Tesla Perspective

ERCOT Grid: AGS-ESR

Functional Specification and

Test Requirements

Test 2: Phase Angle Jump

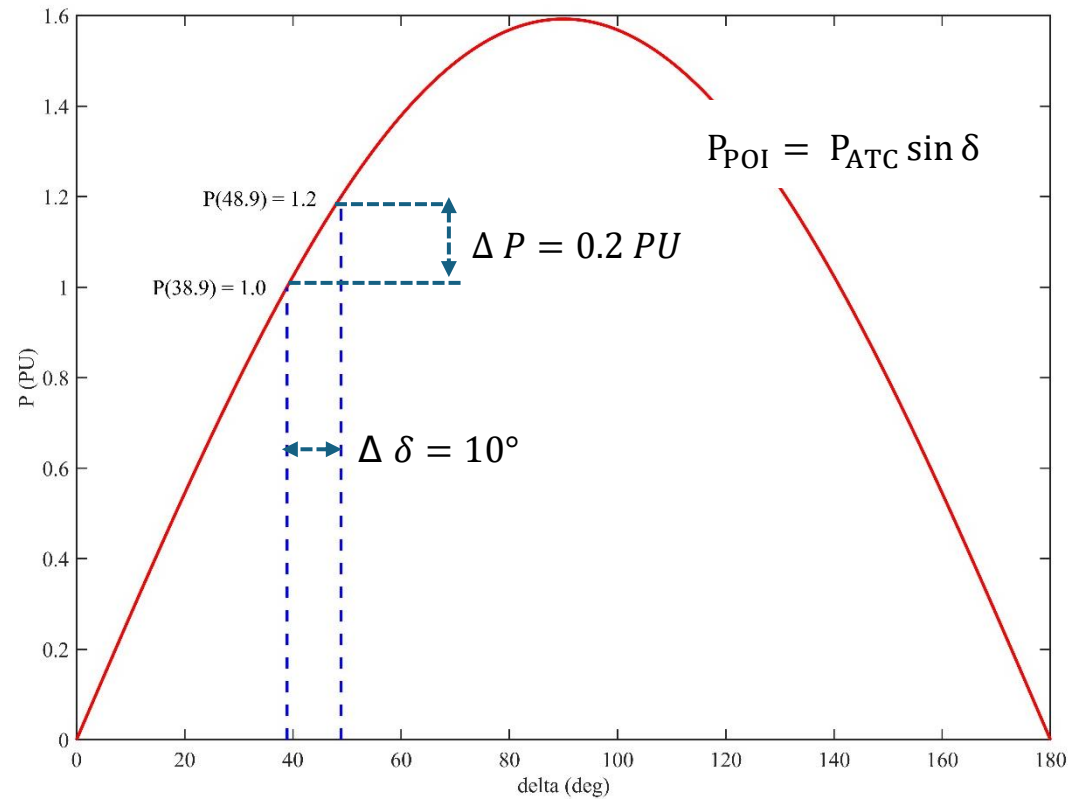
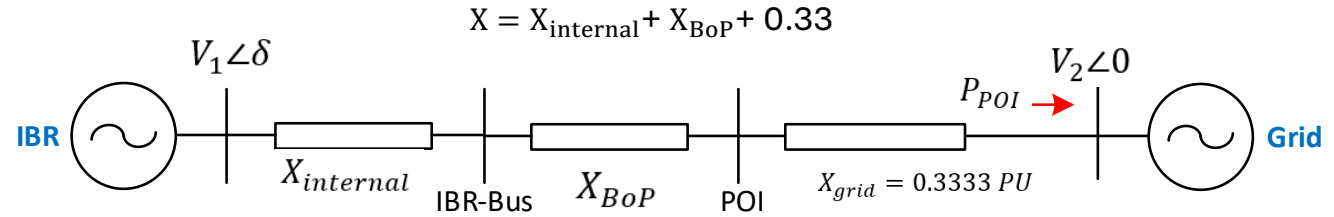
Power change is a function of total impedance and the requirement is not always achievable

- ΔP at least 0.2 PU for 10-degree angle change

$$\delta_0 \leq 38.9, \text{ or } X \leq 0.63 \text{ PU}$$

$$X_{\text{internal}} + X_{\text{BoP}} \leq 0.29 \text{ PU}^*$$

- ΔP at least 0.5 PU for 25-degree angle change

$$X_{\text{internal}} + X_{\text{BoP}} \leq 0.25 \text{ PU}^*$$

Test 2: Phase Angle Jump

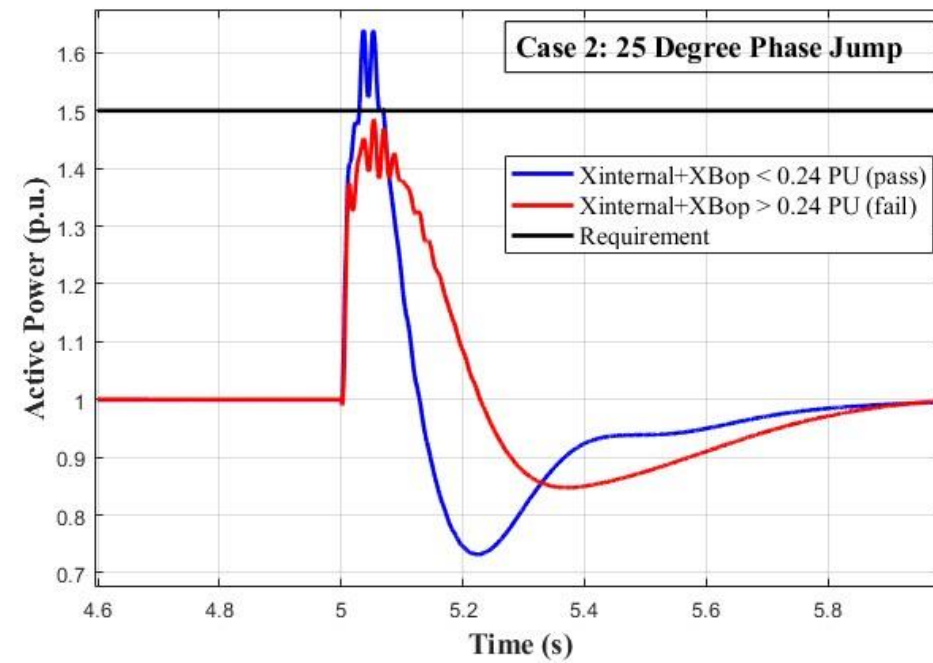
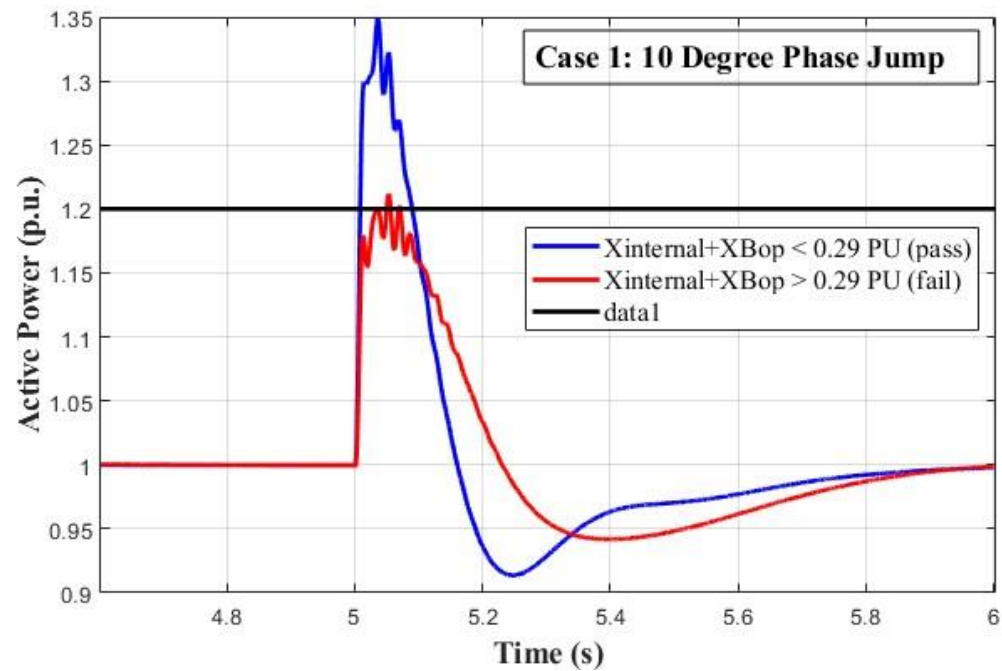
Simulation results confirm the boundary condition

Test 3: Small Voltage Disturbance

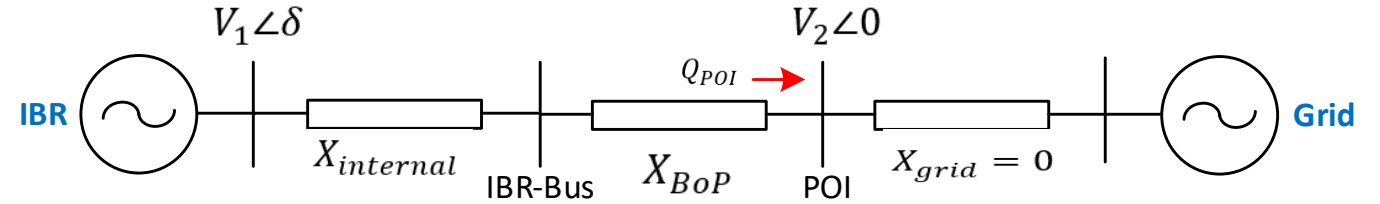
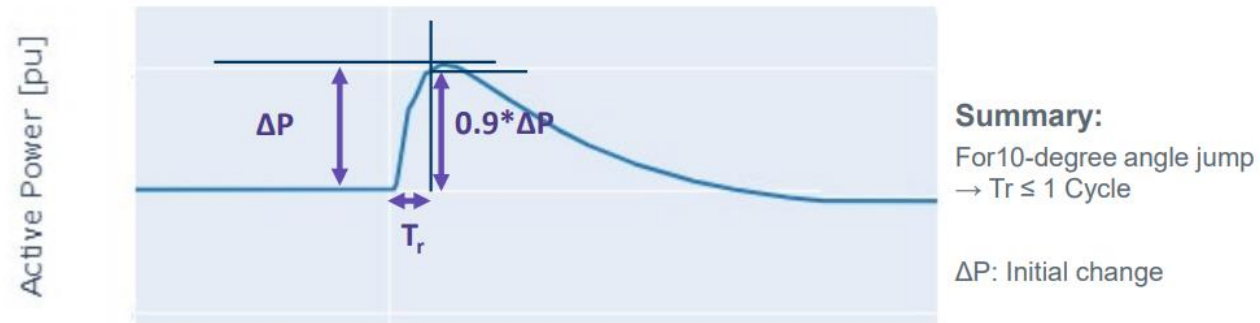
Reactive power change requirement is achievable

- ΔQ of at least 0.03* PU for 3% voltage change

$$X \leq 0.95 (\cos \delta \cdot (2V_2 \pm \Delta V) - V_1)$$

$$X \leq 0.92 \text{ PU}$$

- Phase Angle Jump

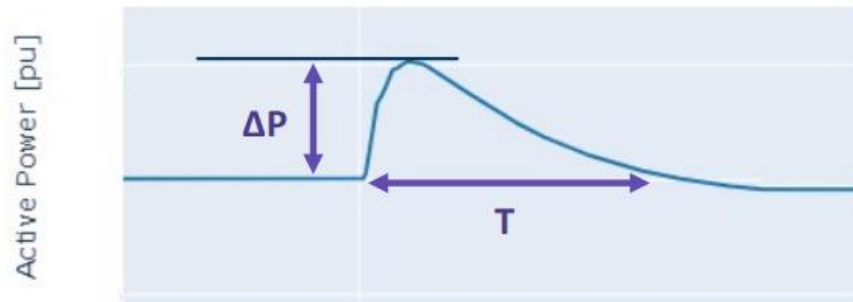
Does the 3-cycles condition apply only when the plant reaches the current limit?

Figure 3. The frequency profile for frequency change and inertia response test

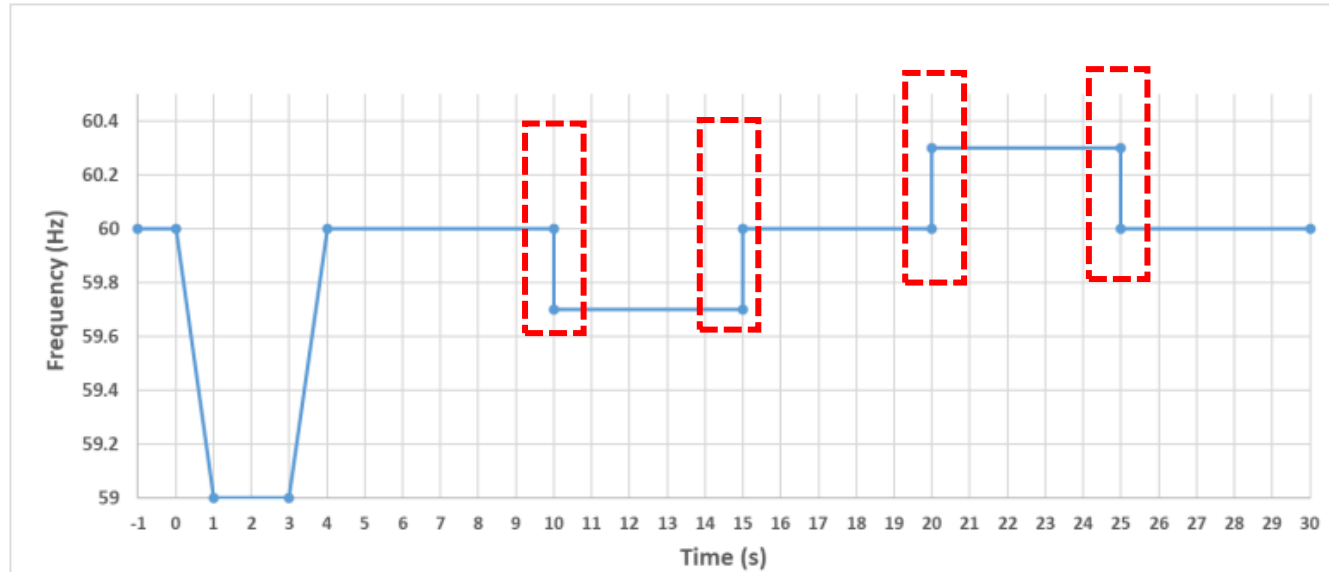
Is it intentional to have a step change in frequency rather than a rate of change of frequency (ROCOF)?
